**Department of Planning and Environment**
Issued under the Environmental Planning and Assessment Act 1979
Approved Section 4.55 (1A) Modification Application
No: SSD 10437 MOD 1 Granted on 16 August 2022
Signed: AW Sheet No: 1 of 21

Project
WATERLOO METRO QUARTER DEVELOPMENT

Sheet title
General Arrangement Plan
Ground Floor Plan

Sheet title
General Arrangement Plan
Level 3-5 Plan

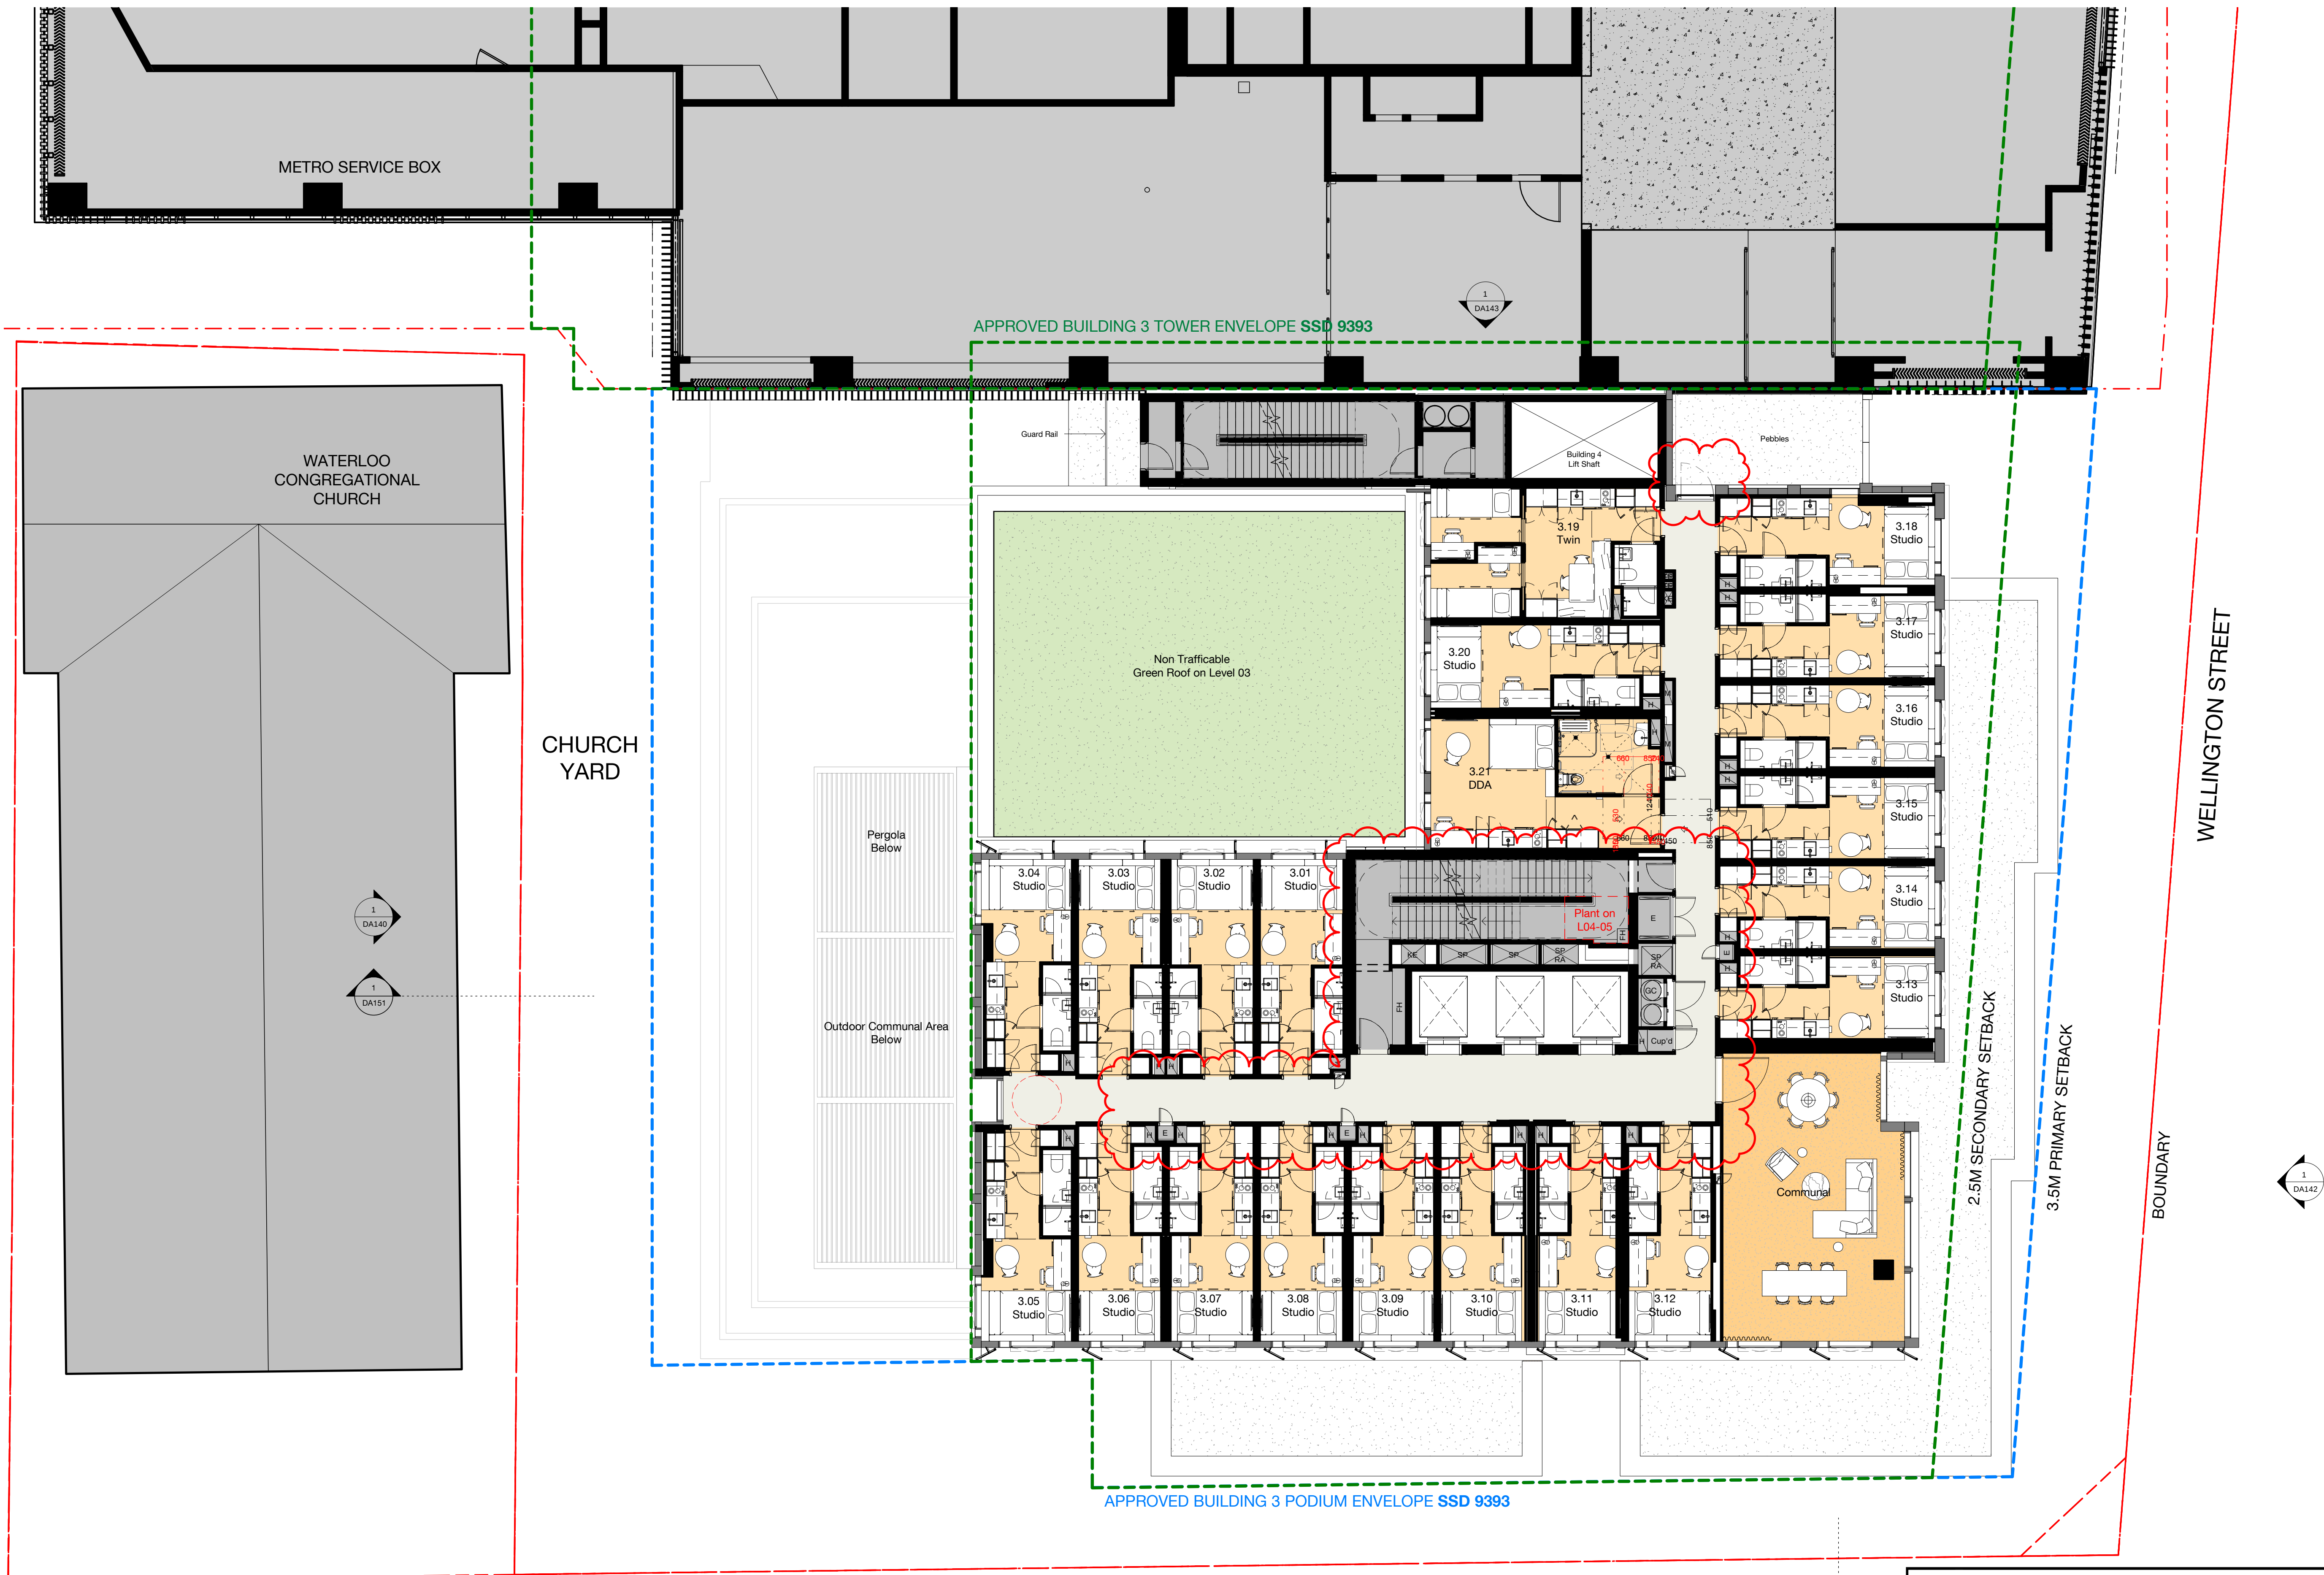
- Modification Changes
- Student Accommodation - reconfiguration to the core and services
 - Additional services door to podium roof
 - Additional services risers

Level 6-15 Plan

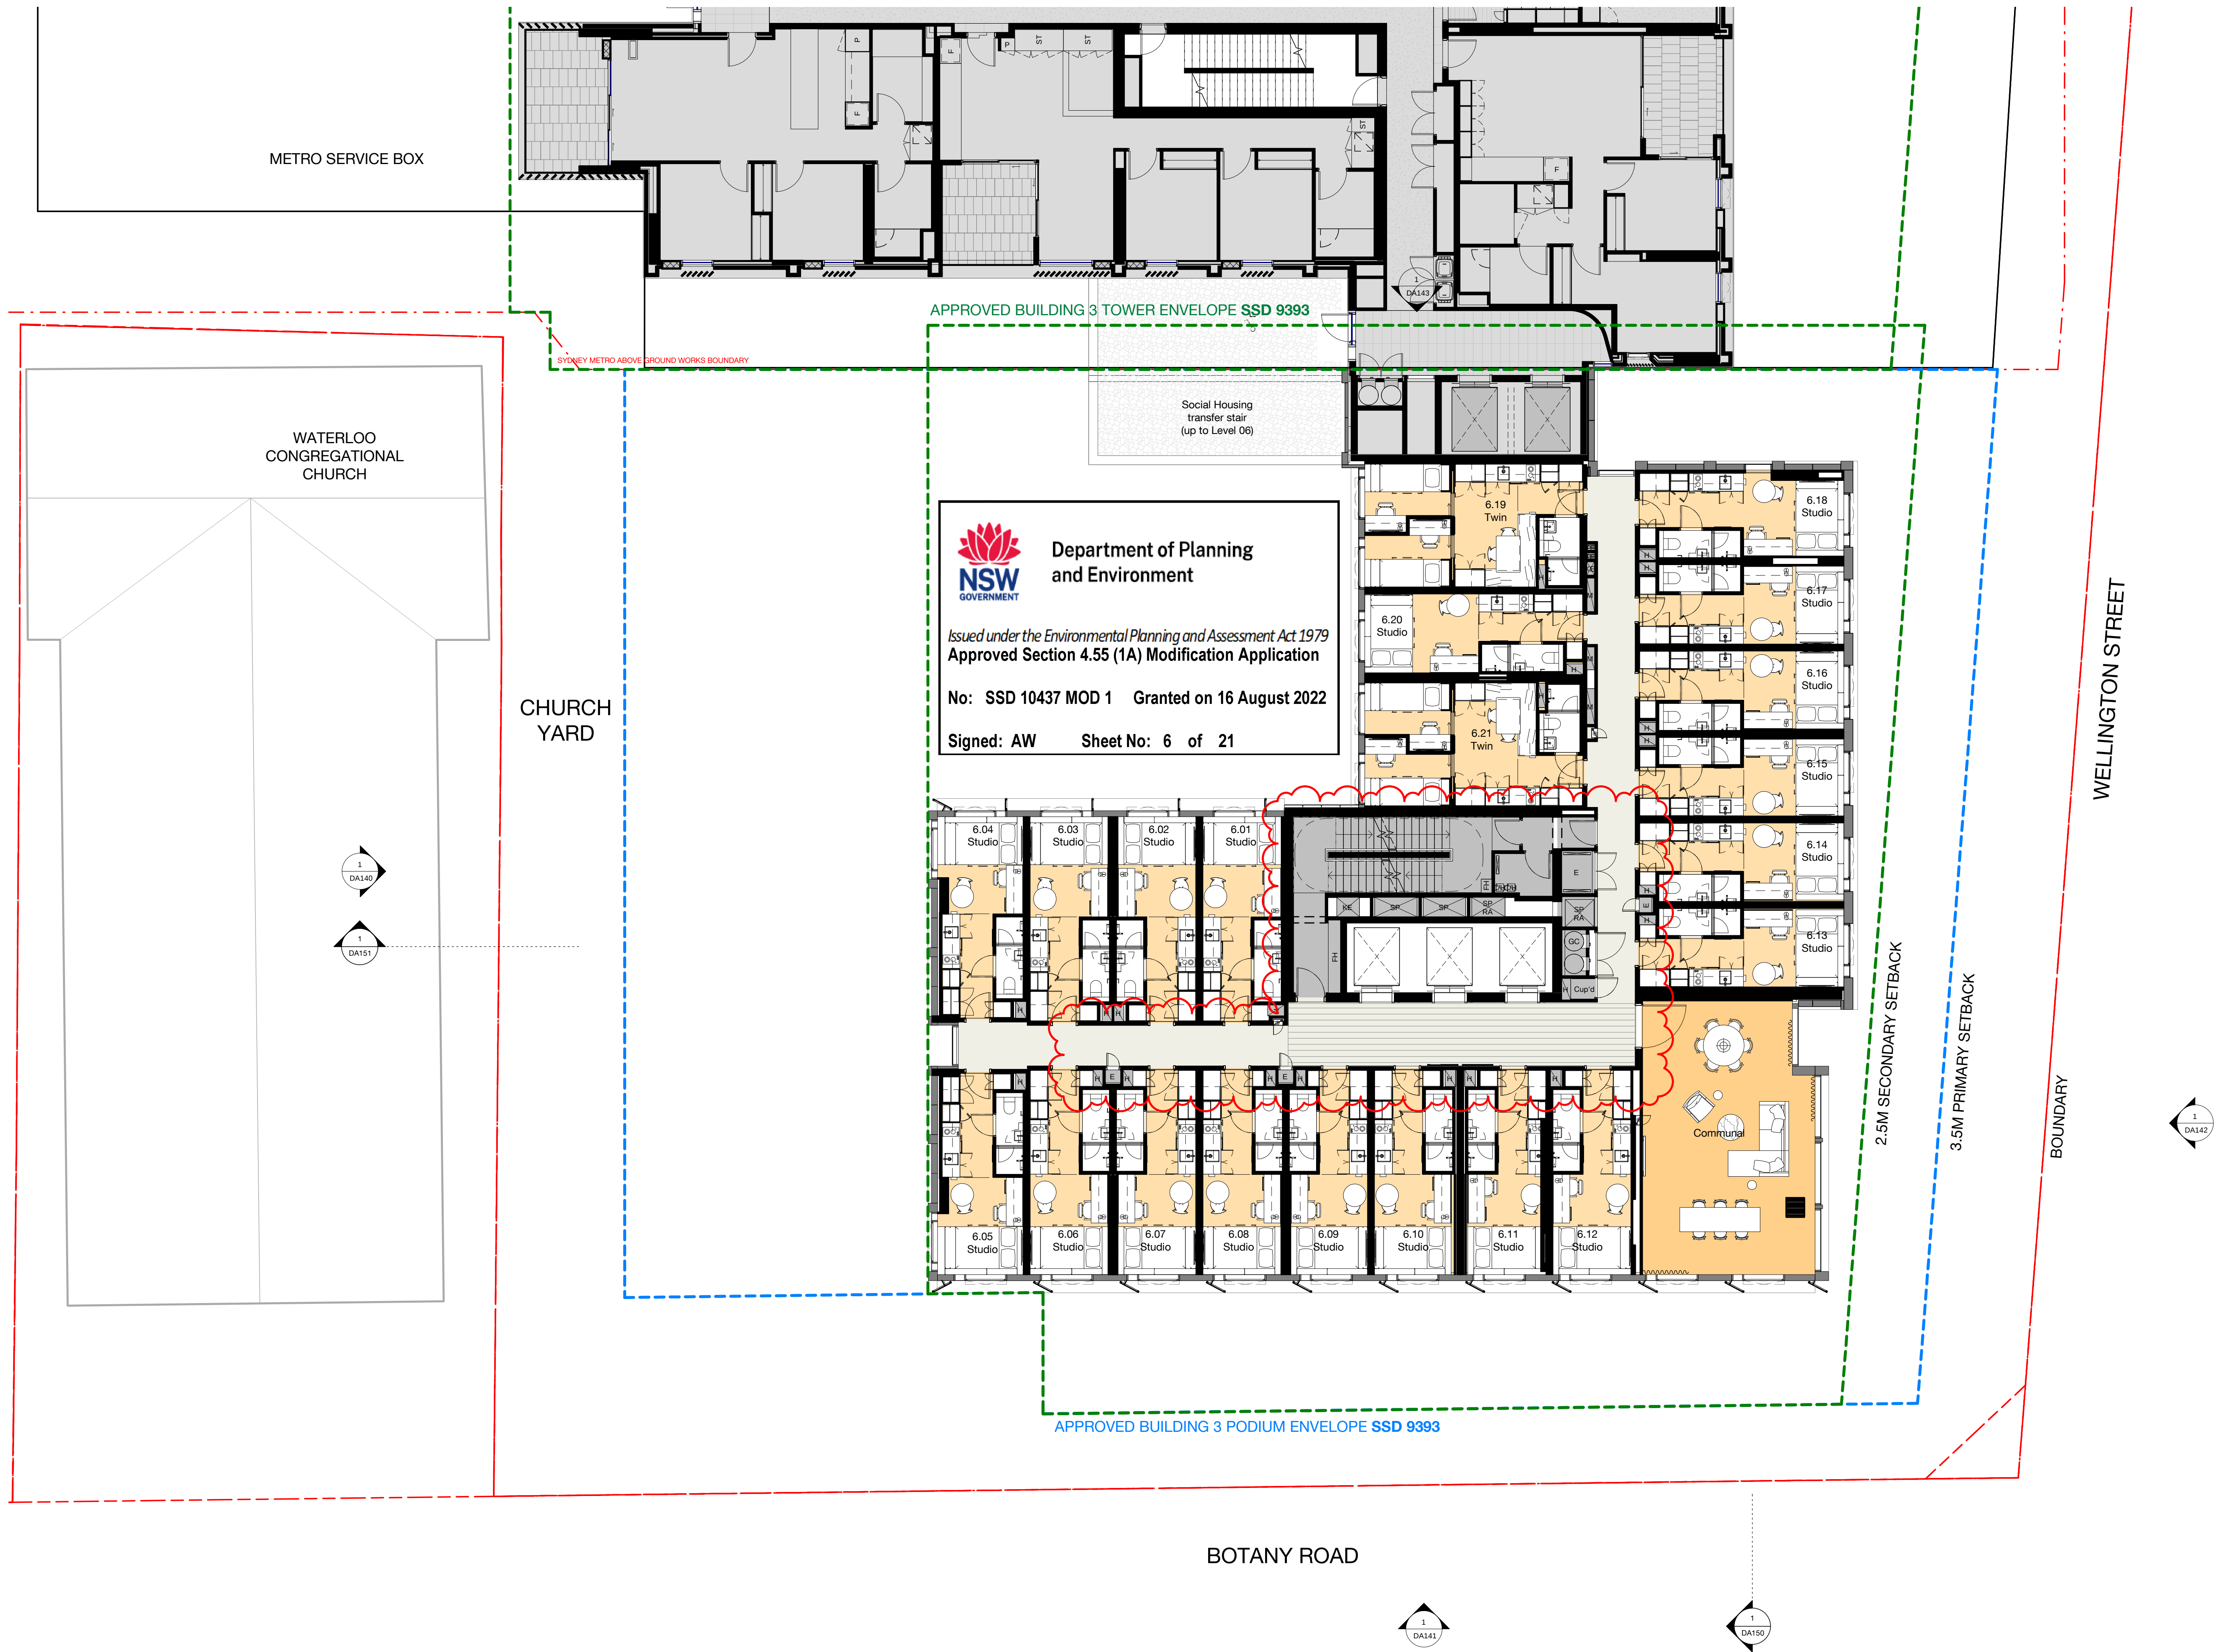
- Student Accommodation - reconfiguration to the core and services
- Additional services risers

Sheet title
General Arrangement Plan
Level 16-22 Plan

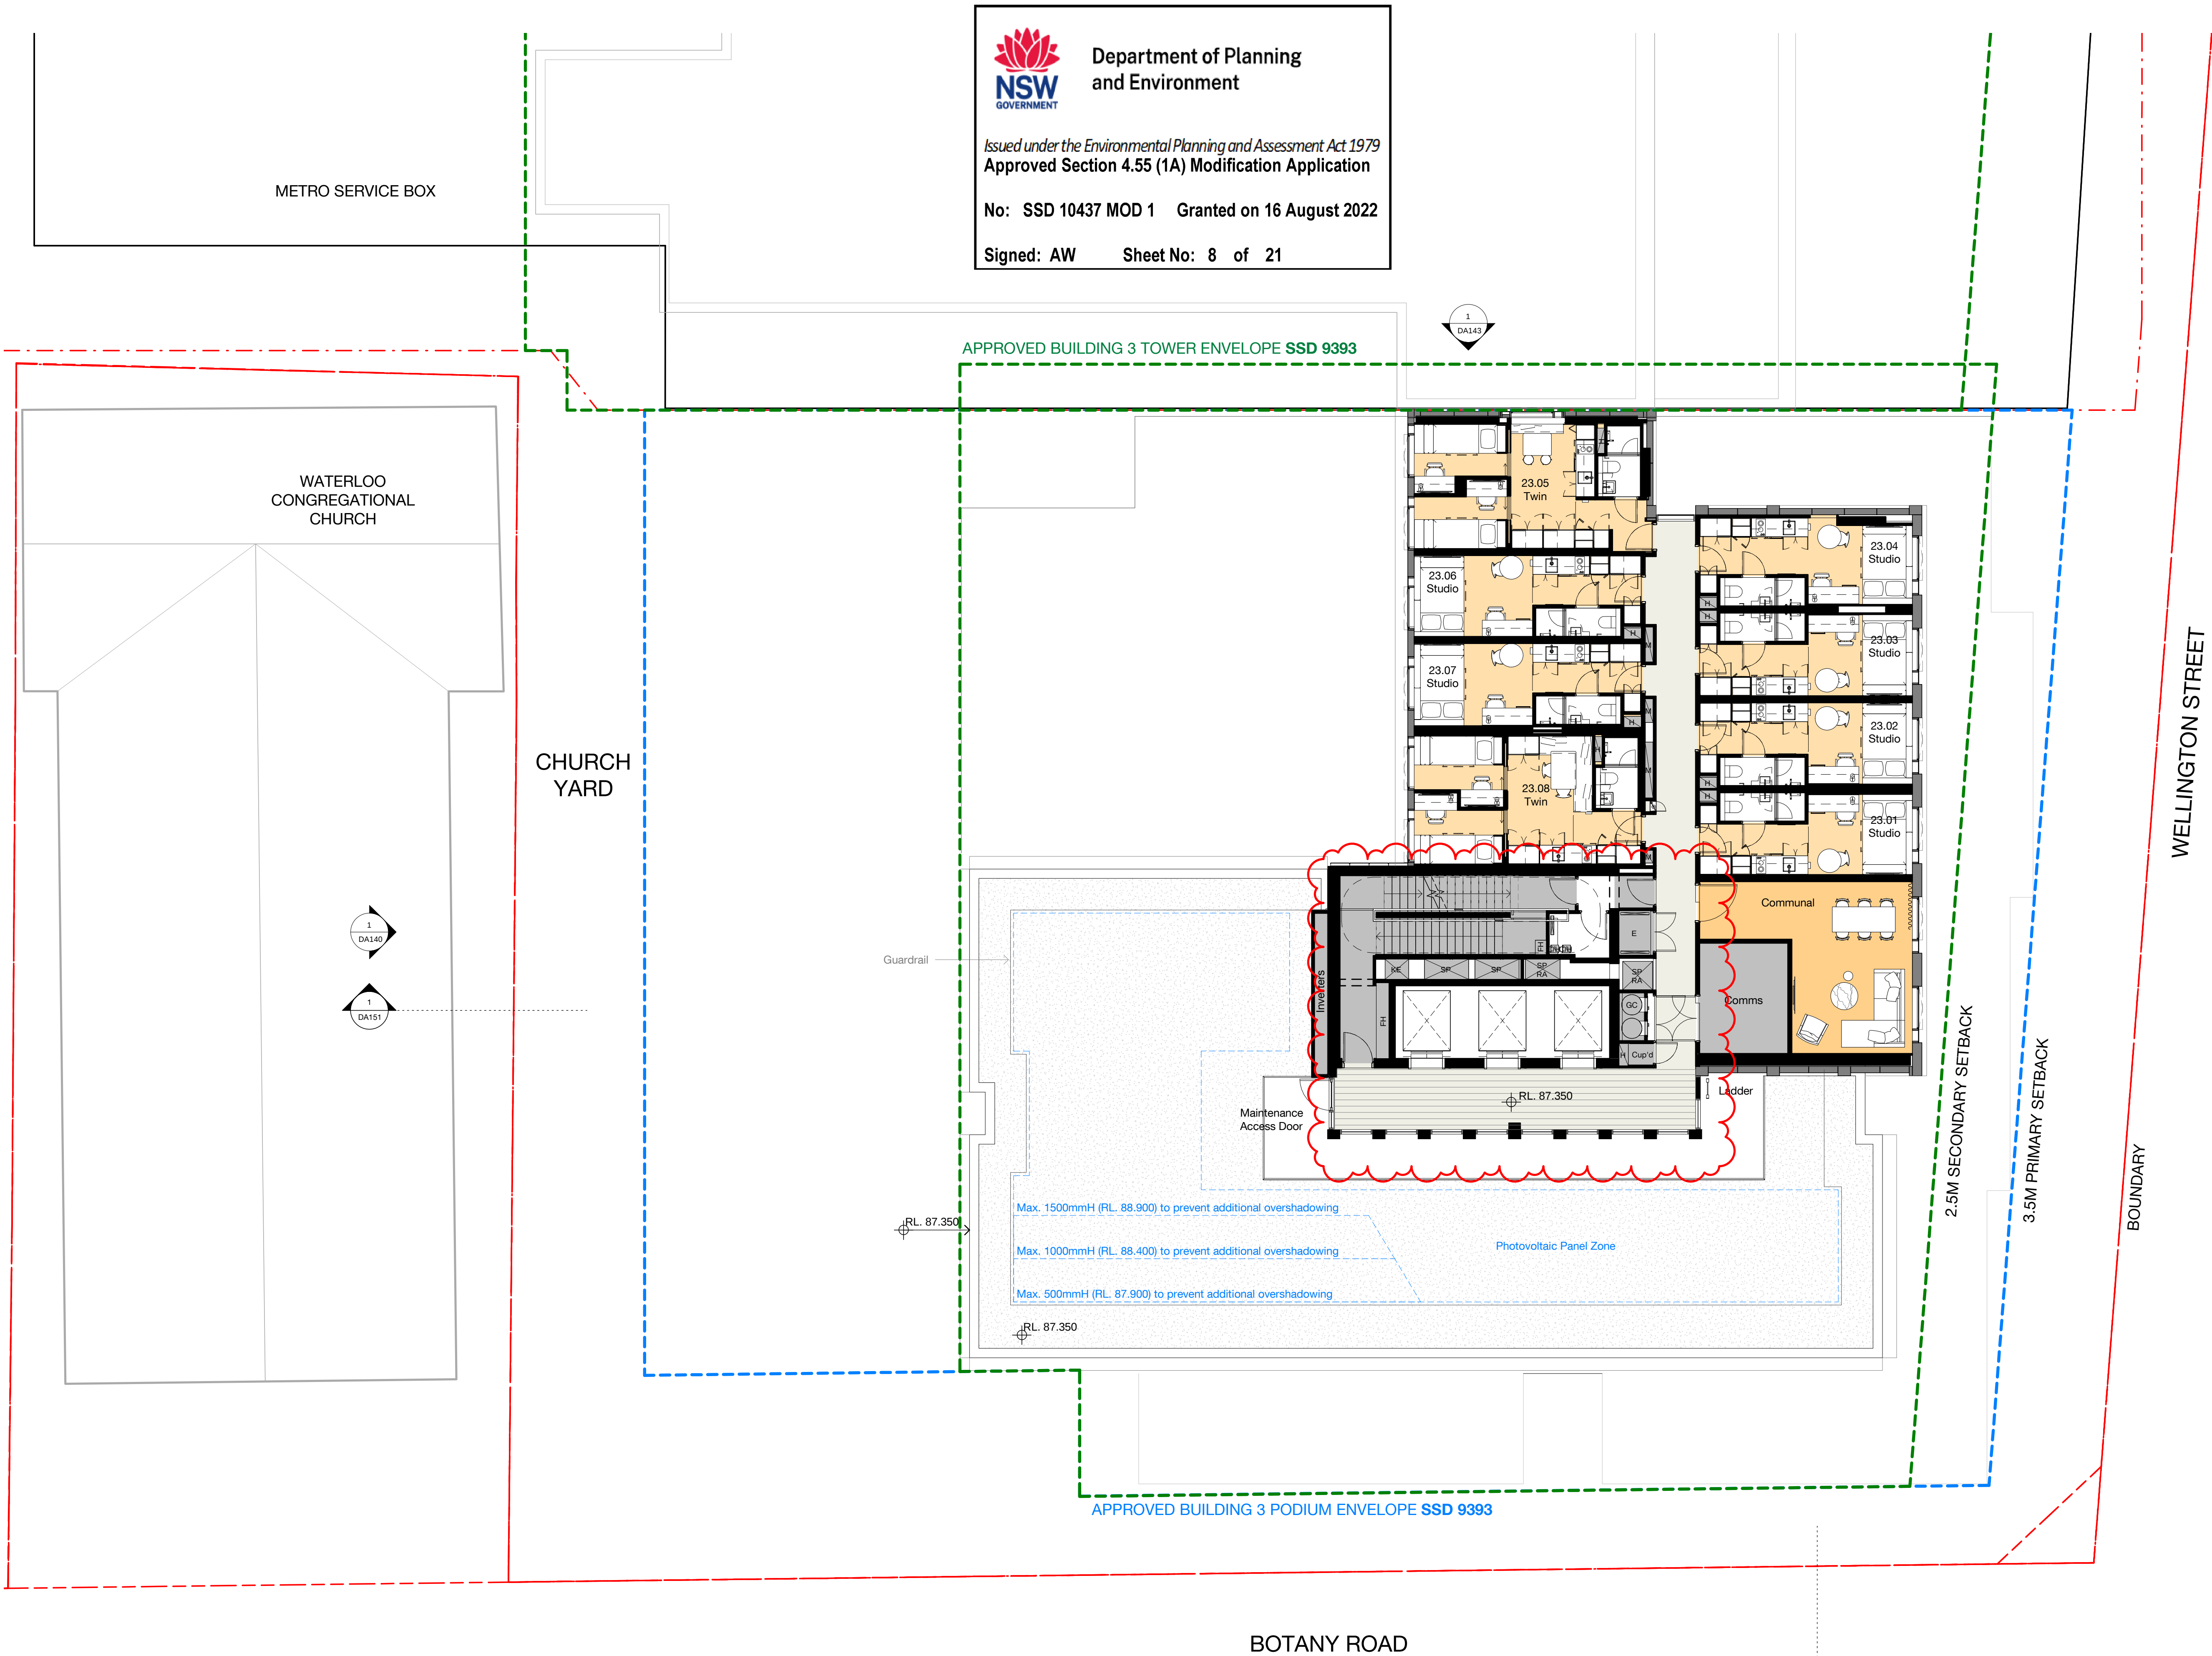
- Student Accommodation - reconfiguration to the core and services
- Additional services risers
